# Access Compliance Report

### (Curb Ramps)

Intersection ID: 31279	Main Street: MALLARD_GLEN_DR	Cross Street: GARRETT_GRIGG_RD	Location: N
ADA ID: 330CB0A8A780	Ramp Type: PerpDiag	Initial Pass/Fail: Fail	Overall Compliance: No
			Severity Score: 21.25

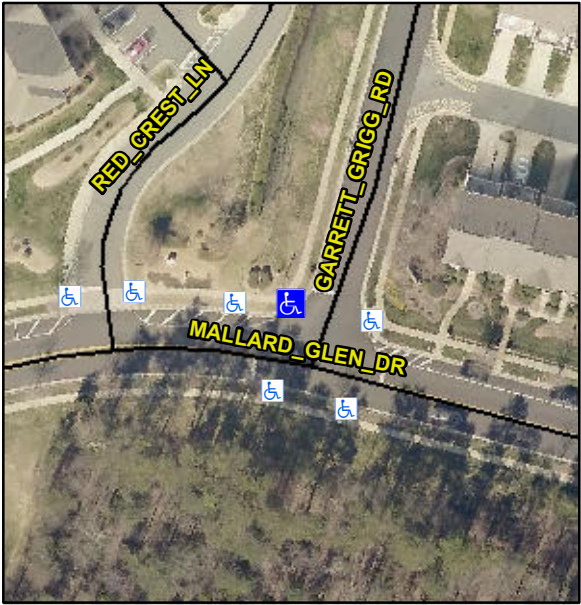
Codes/Mitigation Info/Possible Solution			Field Measurements/Component Compliance		
	Possible Solutions:		<b>Compliance</b>	<b>Description</b>	<b>Data</b>
	<b>Remove &amp; Replace Curb Ramp With Two New Directional Ramps or Equivalent.</b>		<b>No</b>	Ramp Length (in)	<b>58.0</b>
			<b>No</b>	Ramp Width (in)	<b>40.0</b>
			<b>N/A</b>	Flare Type LT	<b>N/A</b>
			<b>N/A</b>	Flare Slope LT (%)	<b>N/A</b>
			<b>N/A</b>	Flare Traversable LT?	<b>N/A</b>
			<b>N/A</b>	Landing Length (in)	<b>N/A</b>
			<b>N/A</b>	Landing Width (in)	<b>N/A</b>
			<b>N/A</b>	Landing Slope (%)	<b>N/A</b>
			<b>N/A</b>	Landing X Slope (%)	<b>N/A</b>
<p>Surveyor Notes:</p> <p><b>N/A</b></p>			<b>N/A</b>	Landing Curb? (Y/N)	<b>N/A</b>
			<b>N/A</b>	Shared Landing?	<b>N/A</b>
			<b>N/A</b>	Gutter Ponding?	<b>N/A</b>
			<b>N/A</b>	Gutter Lip Ht (in)	<b>N/A</b>
			<b>N/A</b>	Painted X Walk1?	<b>No</b>
				X Walk 1 Direction	<b>To SW</b>
			<b>N/A</b>	X Walk 1 Width (in)	<b>N/A</b>

X Walk 1 Slope (%)	<b>1.1</b>
				X Walk 1 X Slope (%)	<b>2.1</b>
			<b>N/A</b>	Ramp inside XWalk1?	<b>N/A</b>
<p>PROW/ADA:</p> <p><b>Not Found, R304.5.1, R304.2.2</b></p>			<b>N/A</b>	Road Slope (%)	<b>1.9</b>
				Road X Slope (%)	<b>0.7</b>
			<b>N/A</b>	Any Obstructions?	<b>N/A</b>
				Obstruction Type	
			<b>N/A</b>		<b>N/A</b>
			<b>Yes</b>	Surface Condition? (G/P)	<b>Good</b>
Total Cost:		\$ 3200.00
